R7FOC003, R7FOC004, R7FOC019
Precaution of using High accuracy 1 Hz output

MCCY-ZB-15-0007-1

Precaution described below is added to the following products in the User's Manual.

1-1. Precaution regarding the clock error correction register (SUBCUD) setting procedure when using the high accuracy 1 Hz output.

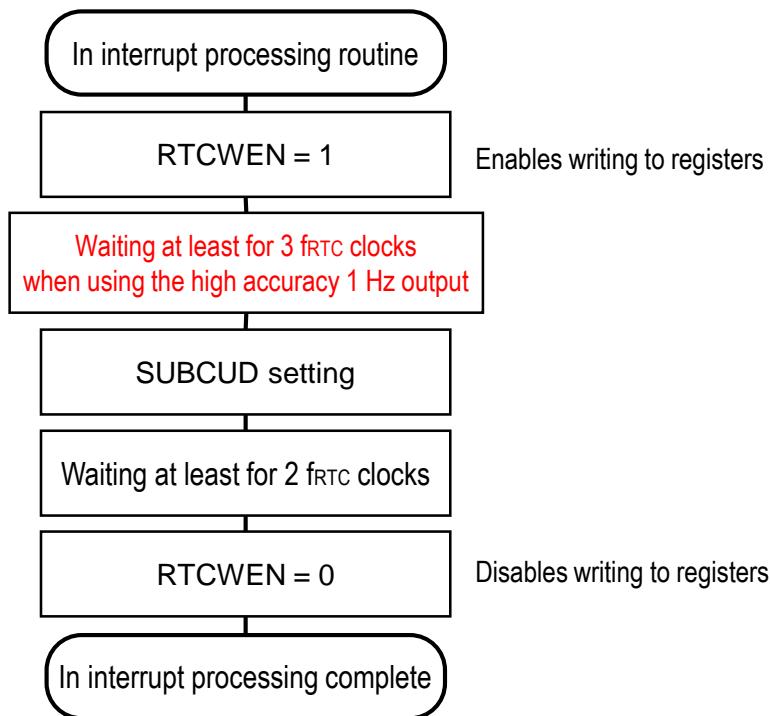
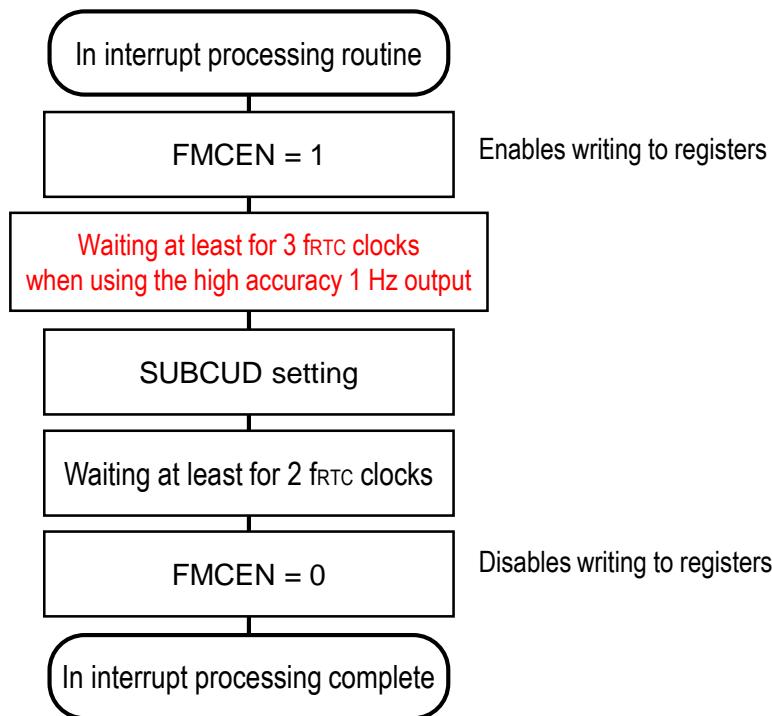
RTC correction may not be successful if there is a conflict between the SUBCUD register rewrite and correction timing. In order to prevent conflict between the correction timing and rewrite of the SUBCUD register, be sure to complete rewrite of the SUBCUD register before the next correction timing occurs (within approx. 0.5 seconds), which is calculated starting from the correction timing interrupt (INTRTIT) or periodic interrupt (INTRTC) that is synchronized with the correction timing.

When using the high accuracy 1 Hz output and rewriting the SUBCUD register, rewrite the SUBCUD register after waiting at least for 3 f_{RTC} clocks.

(1) Set the clock error correction register (SUBCUD) after setting RTCWEN to 1 first. Then set RTCWEN to 0 after completion of the register setting.

(2) Set the clock error correction register (SUBCUD) after setting FMCEN to 1 first. Then set FMCEN to 0 after completion of the register setting.

Figure 7-1. Real-time Clock 2 Diagram

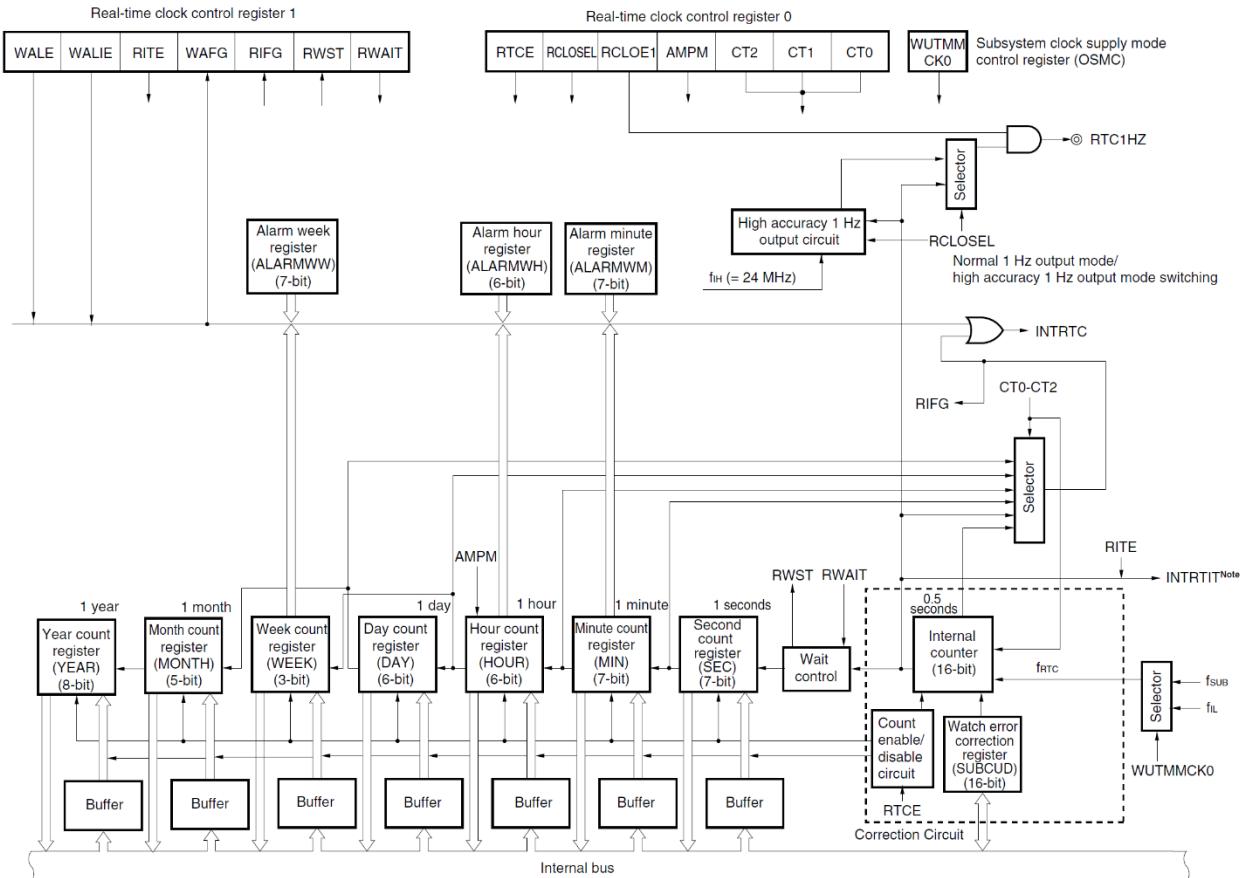
1-2. Root correction of the INTRIT in the Real-time Clock 2 Diagram

Note An interrupt that indicates the timing to get the correction value from the clock error correction register (SUBCUD). The fetch timing is 1 second (f_{SUB} base) interval.
